## Oulton Parish Council Comments on ISH 2 - Onshore Matters.

### Agenda items:-

- i) HDD under the *River Bure*... **CCR15B/CCR15/CCR15A Crossing schedule (Noise & Vibration APP-133) / (APP-178) Crossing ref: RVX001 / unique ID: EA-RVX-MV-001)**

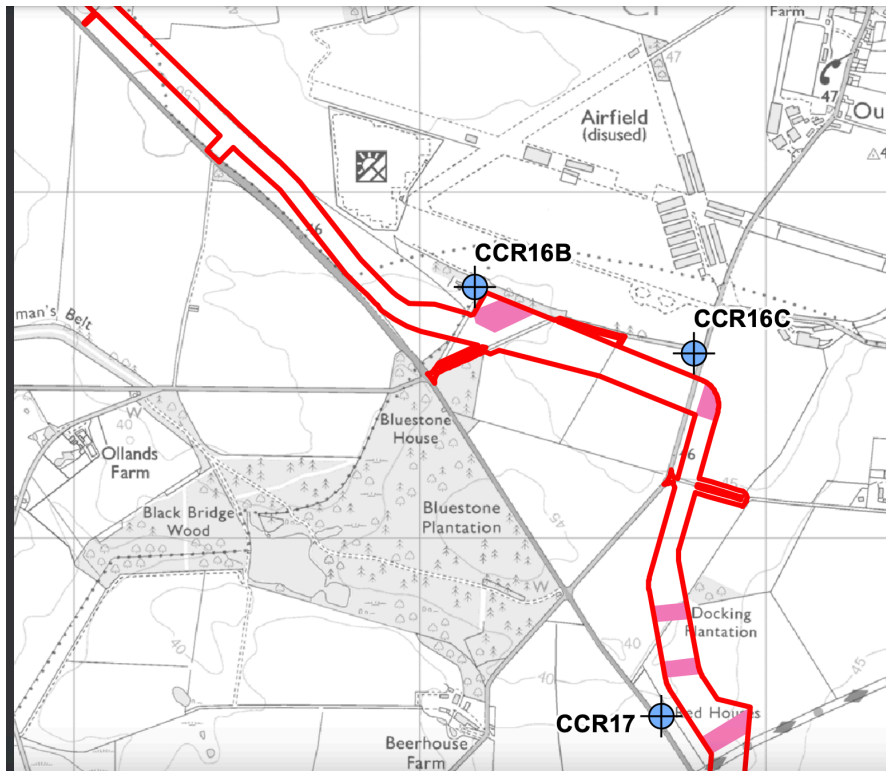
OPC seek clarification on the following relating to **HDD works**:-

- i) Whether these HDD areas will require night-time works?
- ii) Length of proposed works?
- iii) Whether Noise & Vibration assessments at locations documented as sensitive receptors are not just desk based assessments and will further assessments be carried out?

- iv) Will mitigation work be carried out to lessen the impact of Noise & Vibration?
- v) What are the traffic movements for these locations and whether these will involve night-time movements?

**\*(APP-014) ACEW41...B1149**

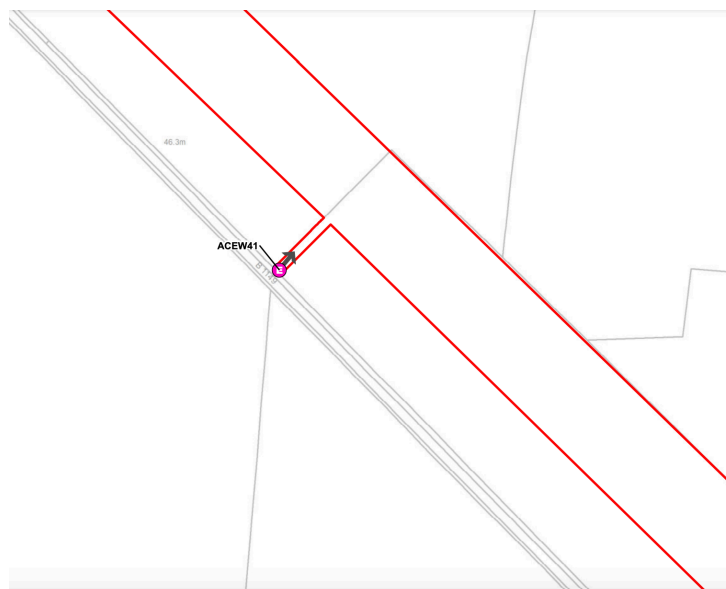
vi) OPC note that there are three access points along **B1149**...(\*see below)  
The B1149 will have cumulative traffic from HP3/Norfolk Vanguard/Boreas.

**(APP-014) \*ACC25b/ACEW42**

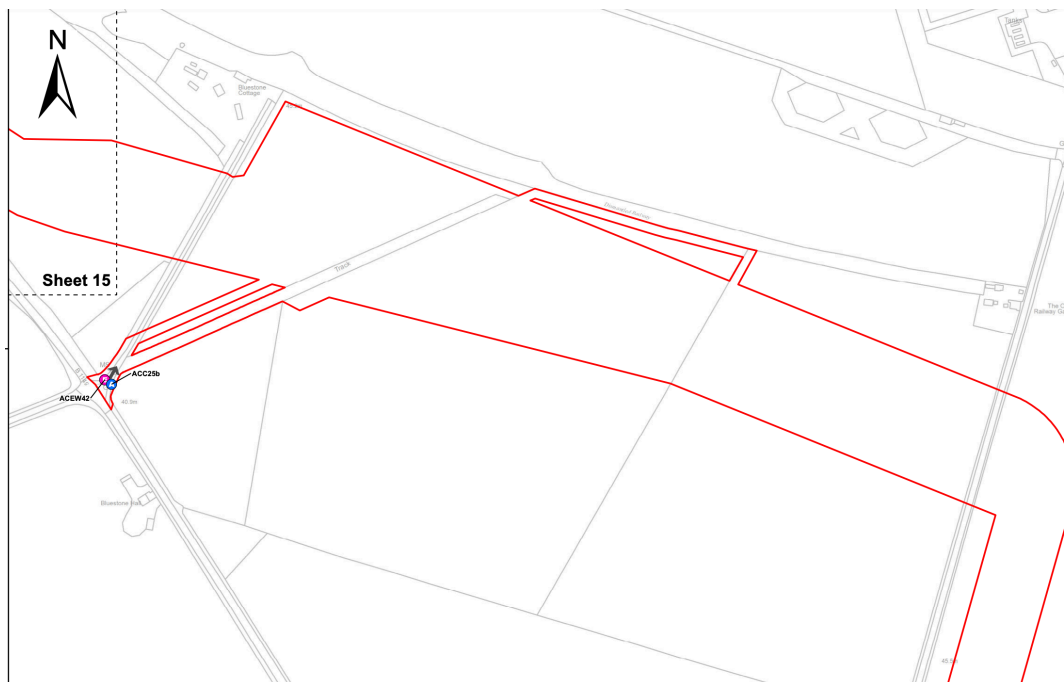
ii) For one property there will be the added cumulative impacts of not only traffic but the addition of HDD along side their property...**(CCR16C APP-133)**  
The other effected \*property will be experiencing HDD/and temporary loss of access to their property. Due to the proposed access to the cable route and HDD **(APP-014 ACC25b/ACEW42) (APP-133 CCR16B)**  
\*Bluestone Cottage

OPC would query whether the resident of this property has been consulted.

*(open map) HDD (APP-133) CCR15 / CCR15A / CCR15B*

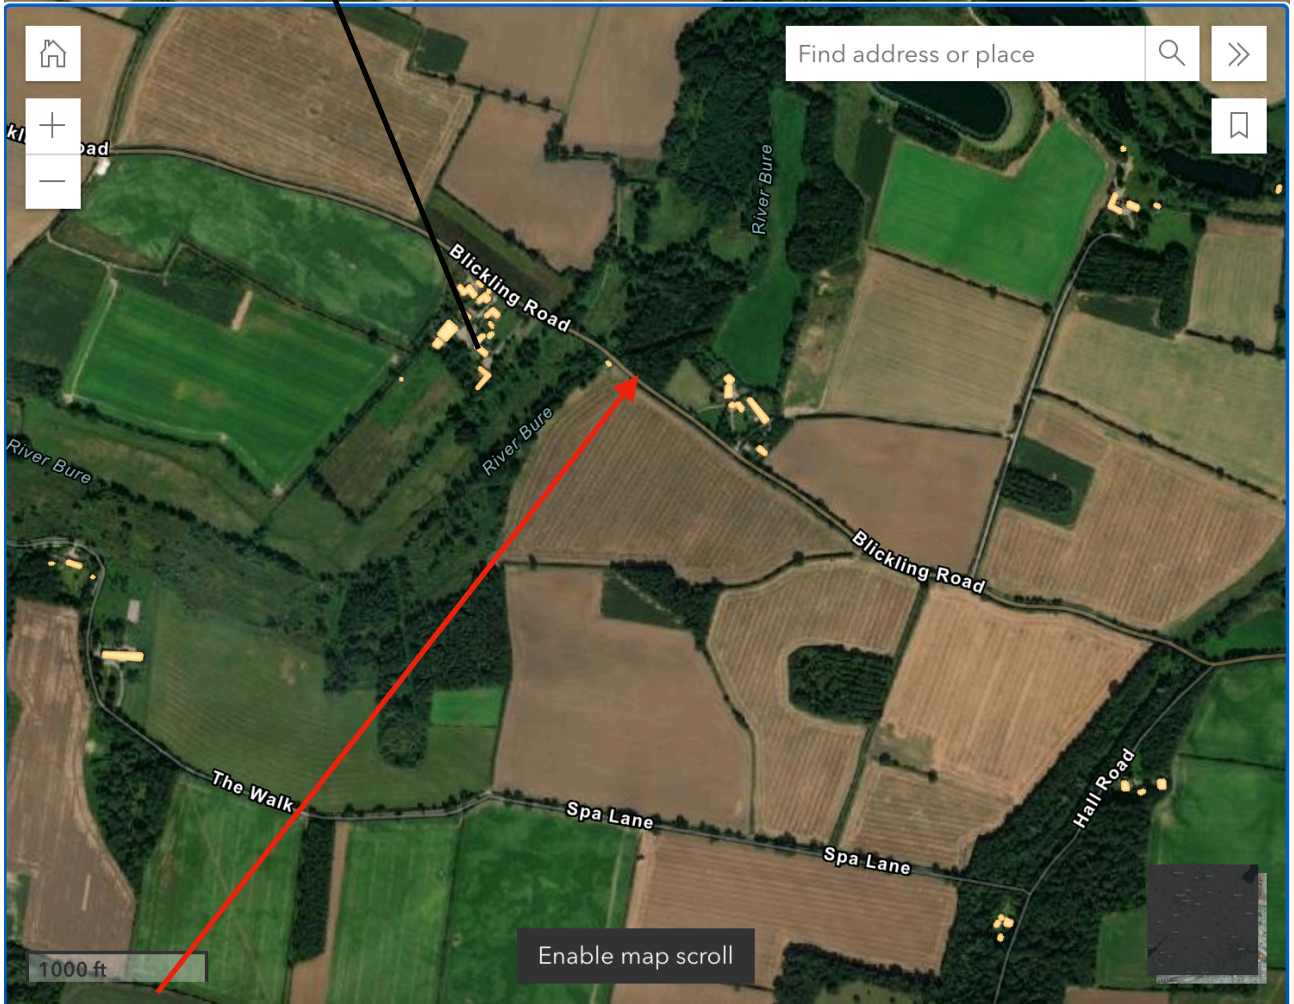
iii) It is further noted that in the *Traffic and Transport Chapter 24 figures*, **Link 57** has been classified as having no cumulative impacts.

Norfolk Vanguard will be using the same link road as SEP/DEP, \* see below **Norfolk Vanguard Link 75** will be used during the construction of their cable route, Link 75 which starts at Saxthorpe roundabout from B1149 along B1354/Blickling Rd).

Therefore SEP/DEP and Norfolk Vanguard traffic numbers for **Link 57** should be considered as cumulative.
